TITLE: **GLENWOOD LOFTS
GRADING & DRAINAGE PLAN**

PRELIMINARY PLAT FOR GLENWOOD LOFTS SUBDIVISION

RECEIVED
MAY 25 2005
HYDROLOGY SECTION

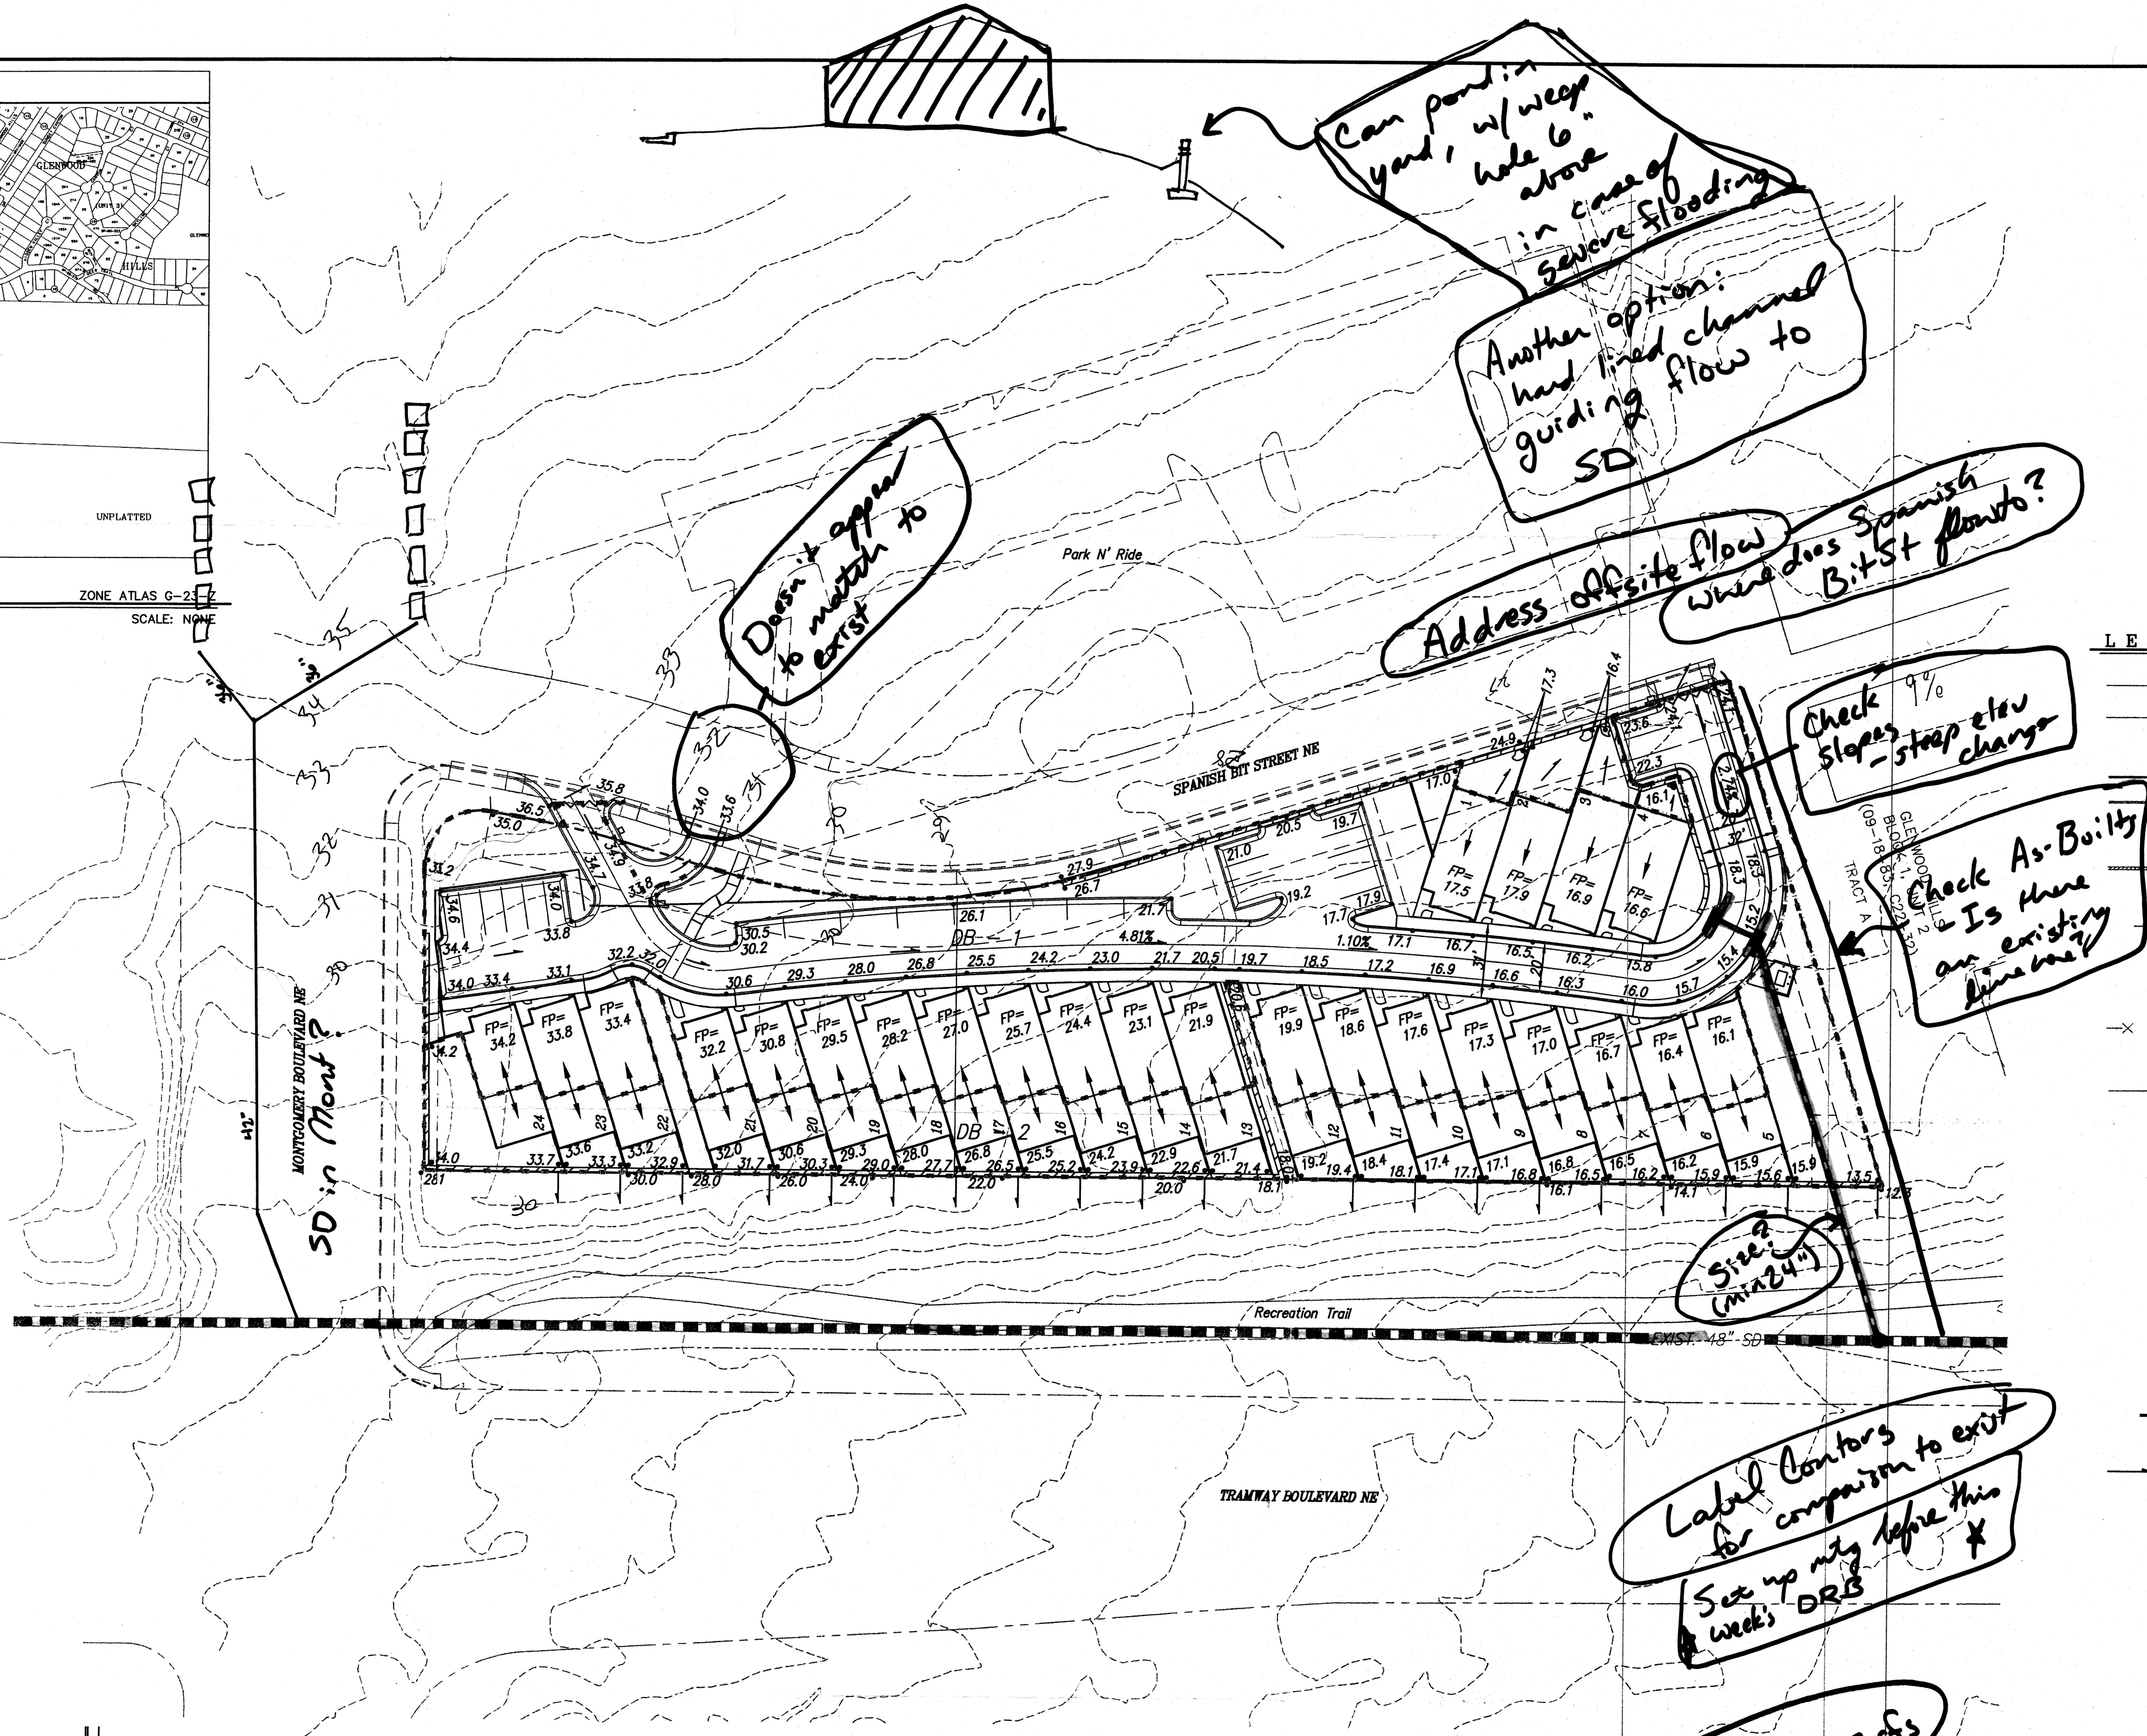
Can pond in yard, w/ weep hole 6" above in case of severe flooding

Another option: hand lined channel guiding flow to SD

Address off-site flow where does Spanish Bit St flow to?

Check slopes - steep elev change

Check As-Built - Is there an existing line work?

Label contours for comparison to exist

See up city before this week's DRB

Flow to inlet: $8.96 - 1.54 = 7.42$ cfs
